DANE COUNTY DEPARTMENT of PUBLIC WORKS, HIGHWAY and TRANSPORTATION

RFB NO. 313083 - ADDENDUM NO. 3

CONSTRUCTION OF EAST HIGHWAY GARAGE – SALT STORAGE FACILITY (BID PACKAGE A) AND MEDICAL EXAMINER OFFICE BUILDING (BID PACKAGE B)

**DEPARTMENT OF PUBLIC WORKS,
HIGHWAY & TRANSPORTATION
3562 COUNTY HIGHWAY AB
MCFARLAND, WISCONSIN**

6 OH Door Track Support Detail
1/2" = 1'-0"

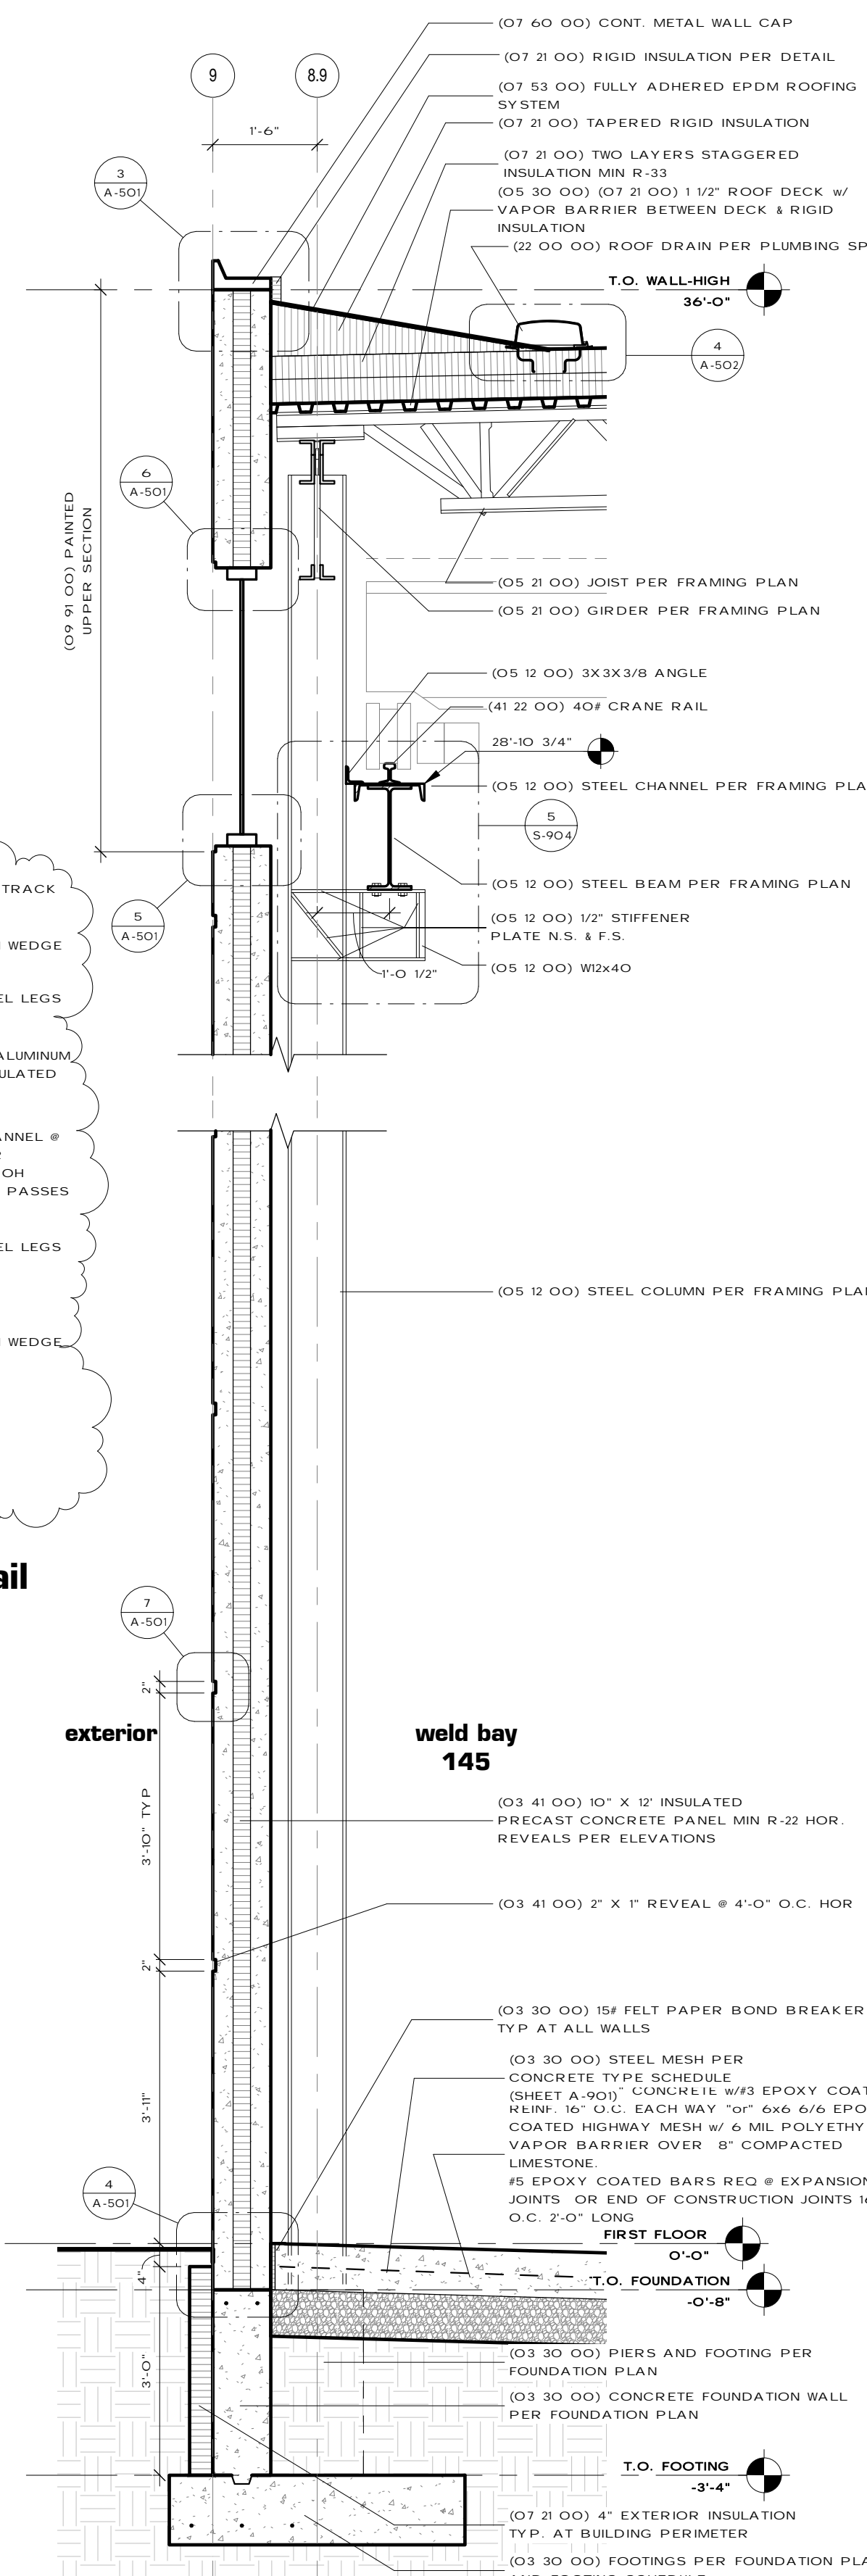
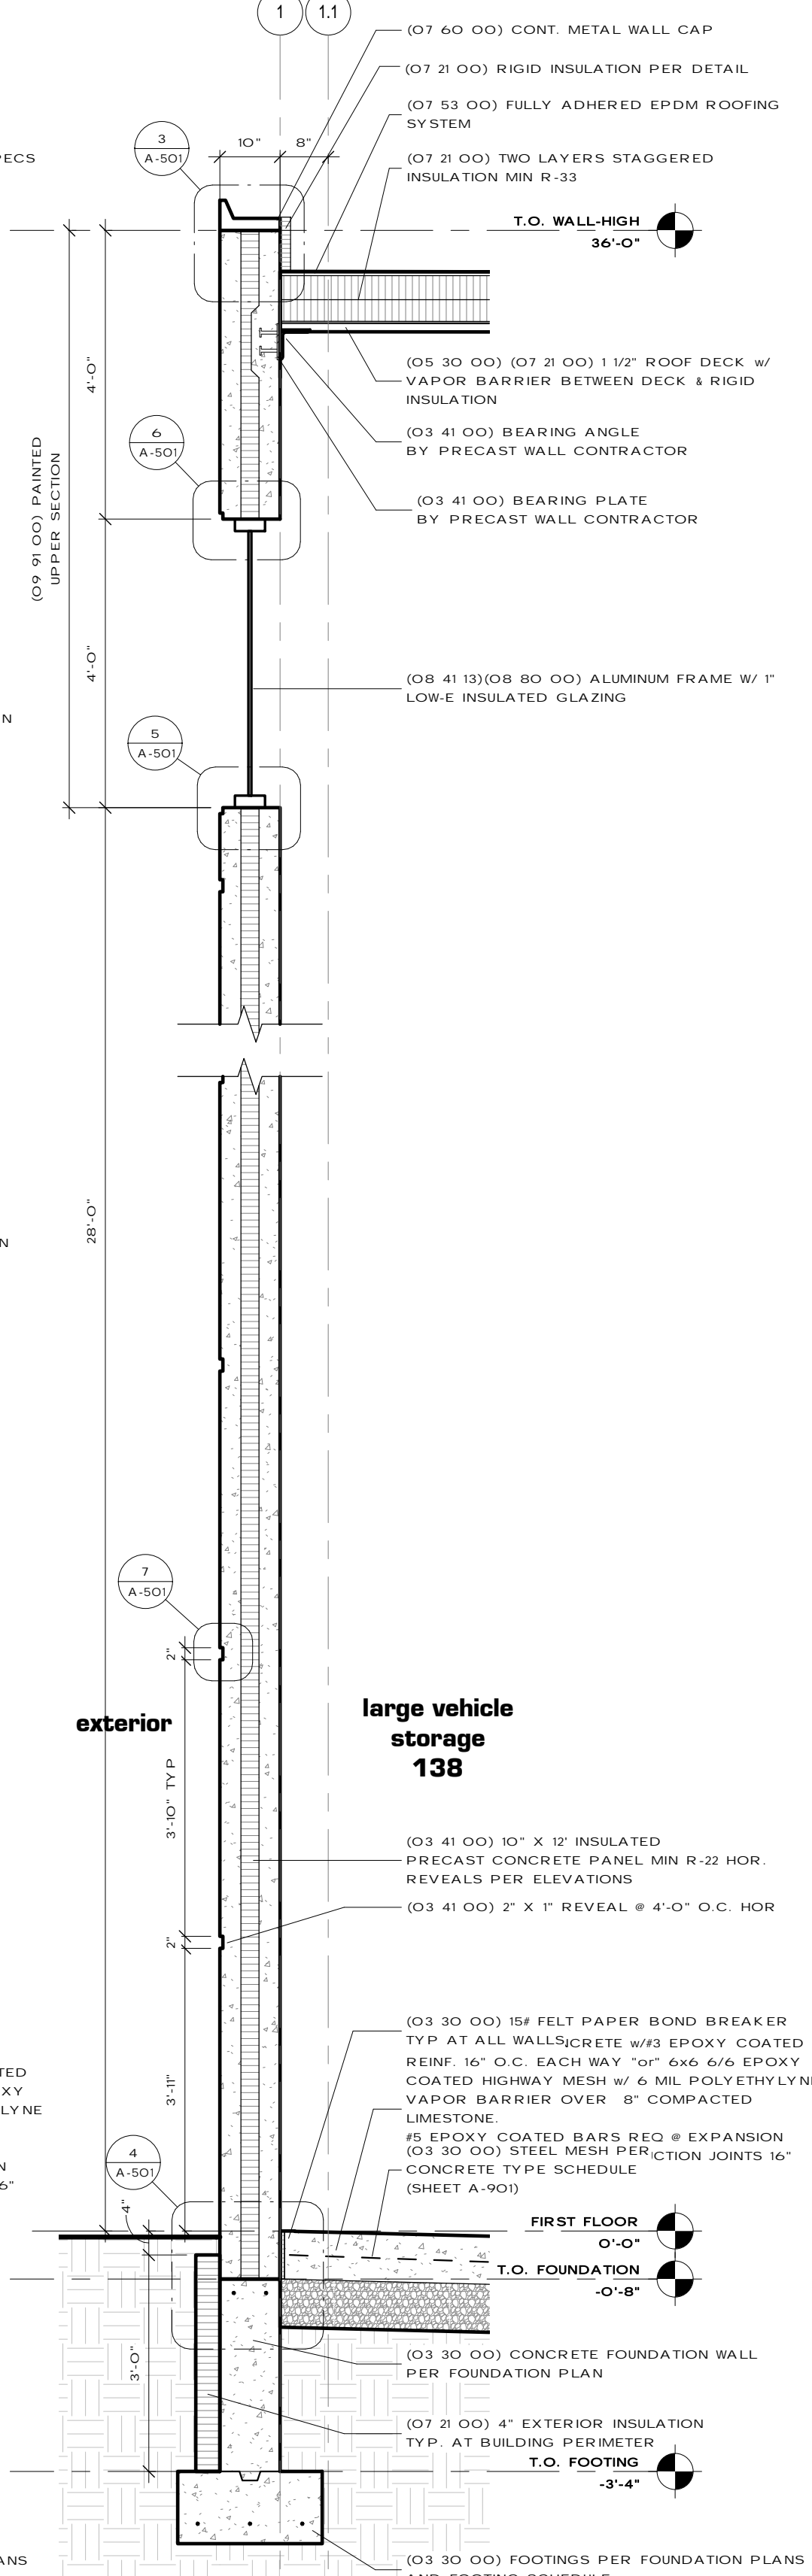
1. Detail 3 – Wall Section. See added detail to this sheet for steel support of sectional door track. See revised sheet included in this addendum.
2. Detail 6 – Added detail for steel support of sectional door track. This detail occurs wherever sectional door track passes in front of a window. See revised sheet included in this addendum.

1 Mechanical Site Plan - Base Bid
M-001 SCALE: 1" = 50'-0"

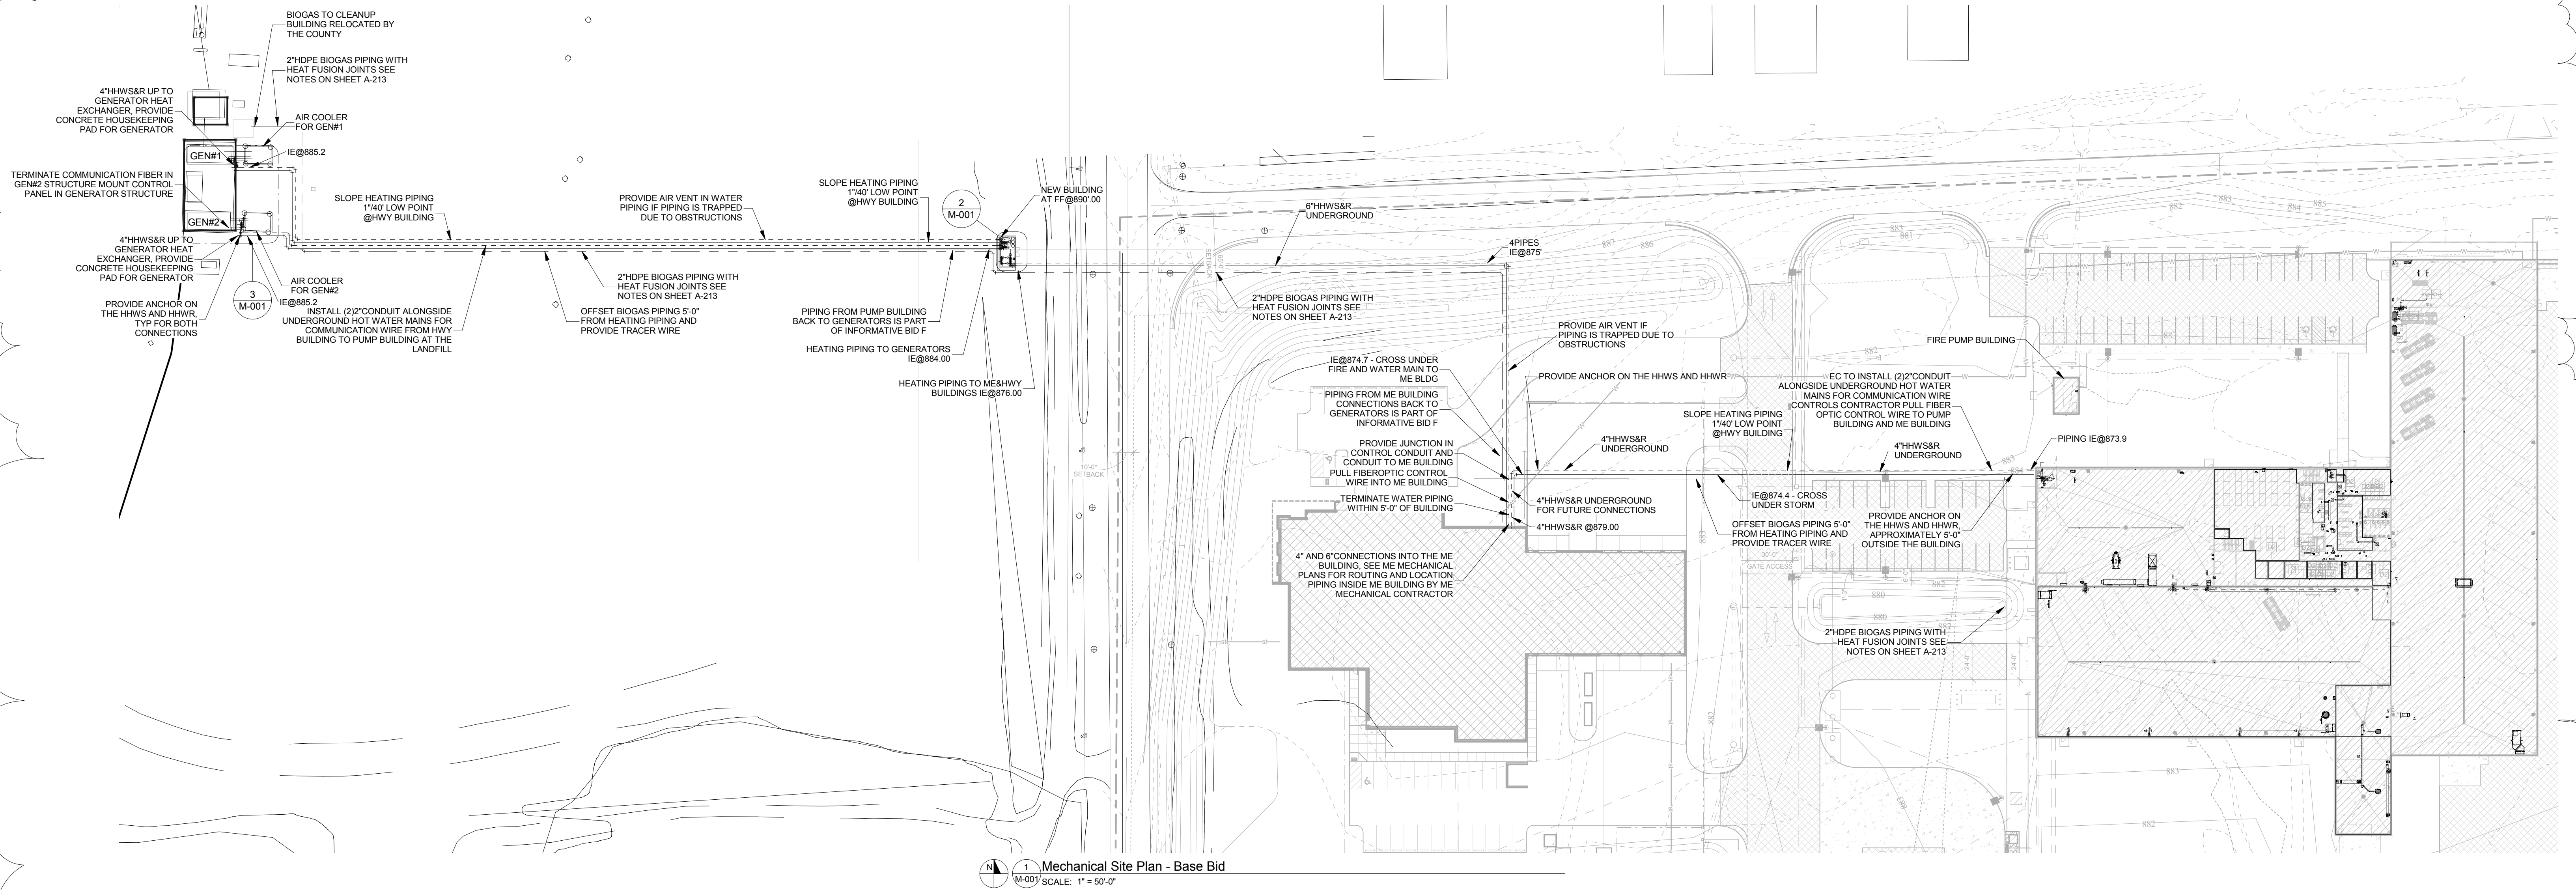
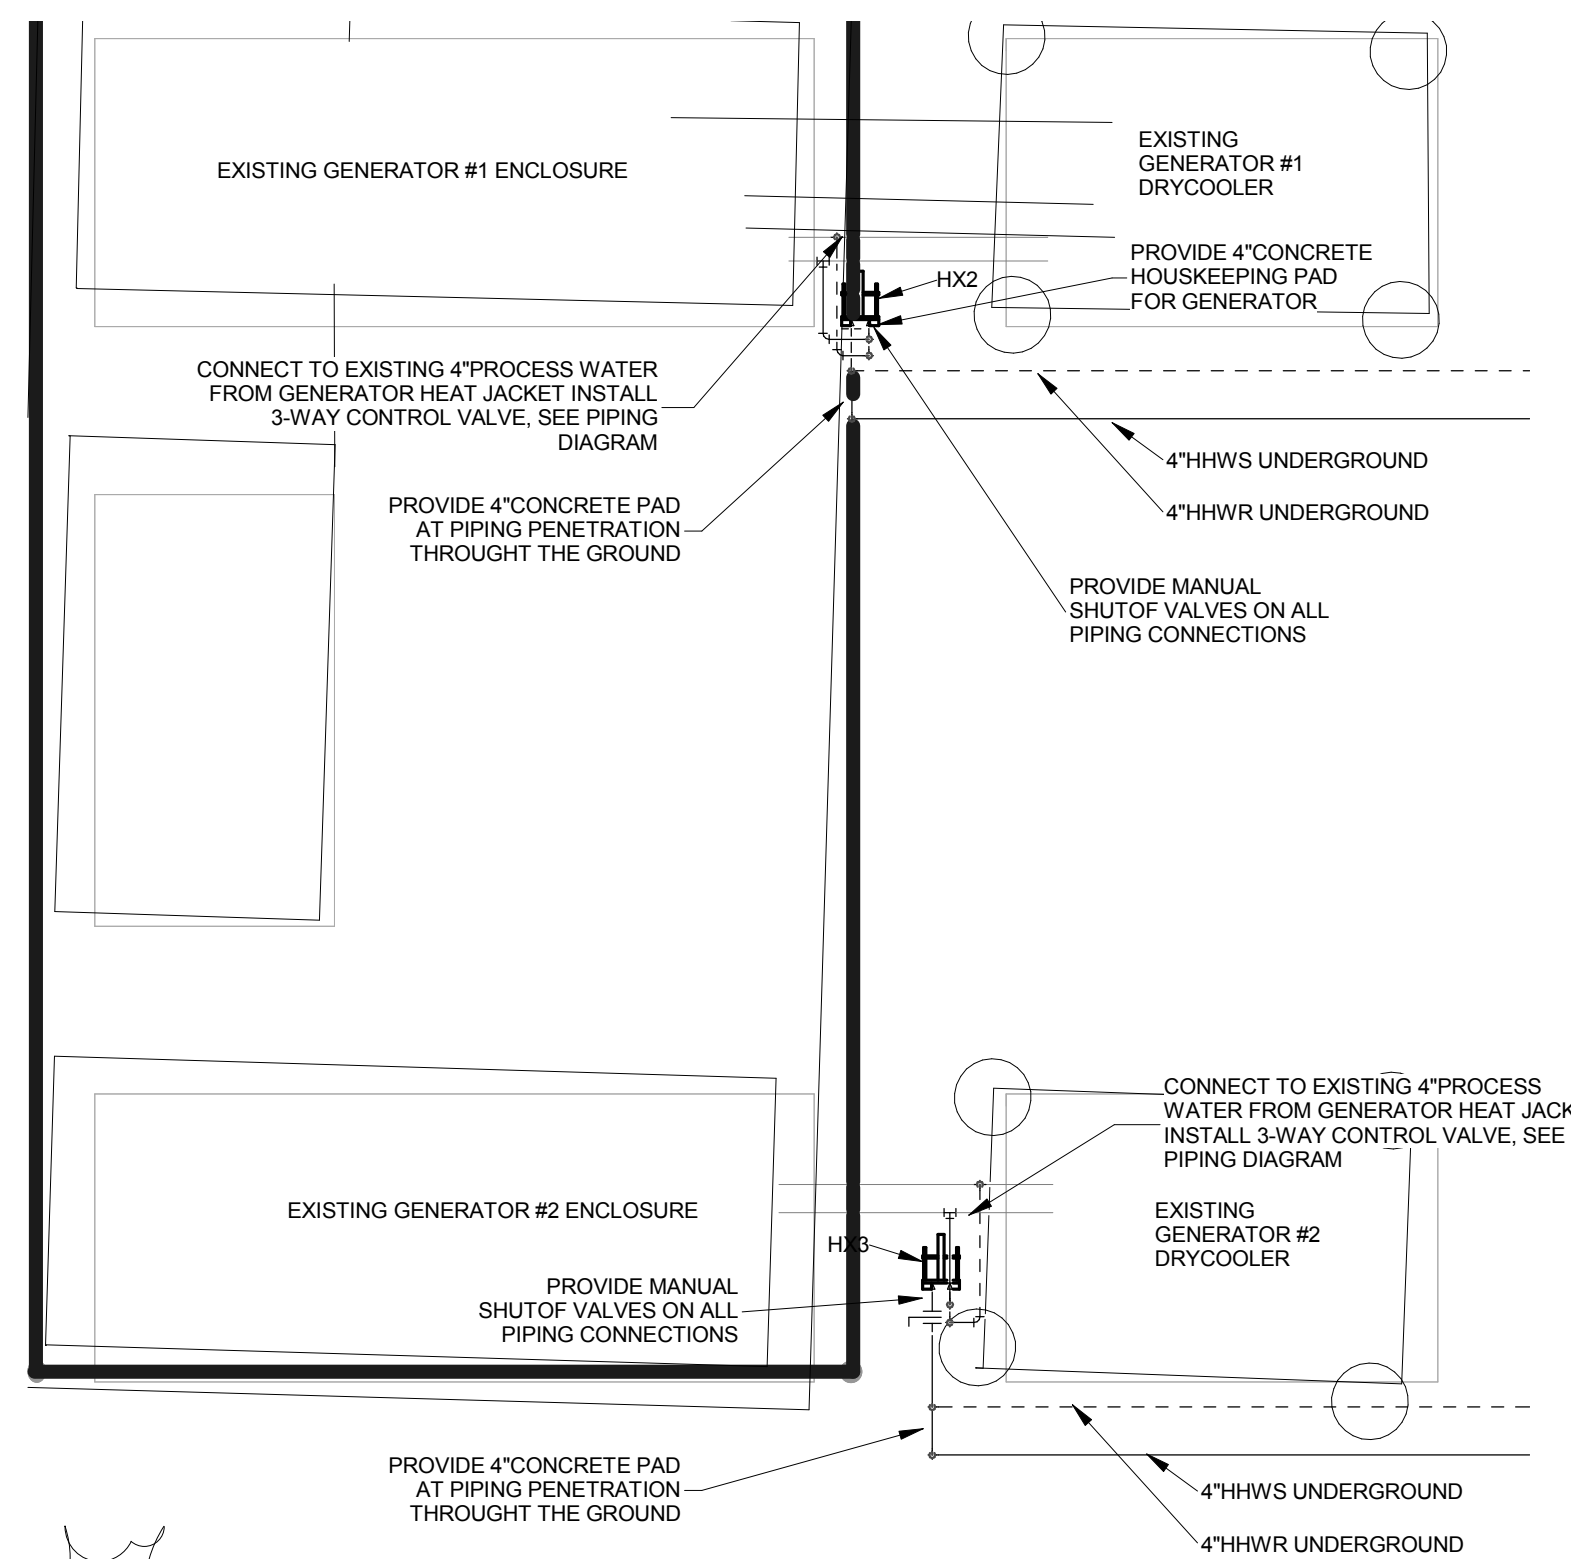
30. **Q:** Sheets C-104 & M-001: Assuming the division 23 contractor is to provide the gas line shown on M-001 that appears to end at the HHWS&R expansion loop west of CTH AB please provide a specification. **A:** See information provided in this addendum.

- d. The CNG piping shown on Sheet M-001 will be run with the other lines by the Site Utility Contractor and stubbed to the fuel dispensing site. Final connections on both ends are by the Fuel Contractor. See notes on Sheet A-213.
